# Product Change Notification (PCN)

Note: While responding, please retain "**PCN Notification:505531**" in the e-mail Subject line for faster response.

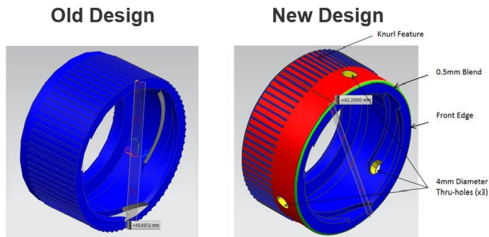
- For increased capacity Molex is adding a second supplier for the XRC 18-14 circuit Coupling Ring
- No impact on fit or function.
  - > The XRC 18-14 Coupling Ring has been modified to incorporate (3) sight holes, for the benefit of visual confirmation of coupling.
  - > knurl modifications offers the benefit of better gripping of the connector and will have a slight impact on form. Both these features are cosmetic
- This supplier is a qualified Molex Supplier of the XRC 24-31 circuit Coupling Ring.
- See attached impacted parts list
- Qualification and samples are available after the dates listed.
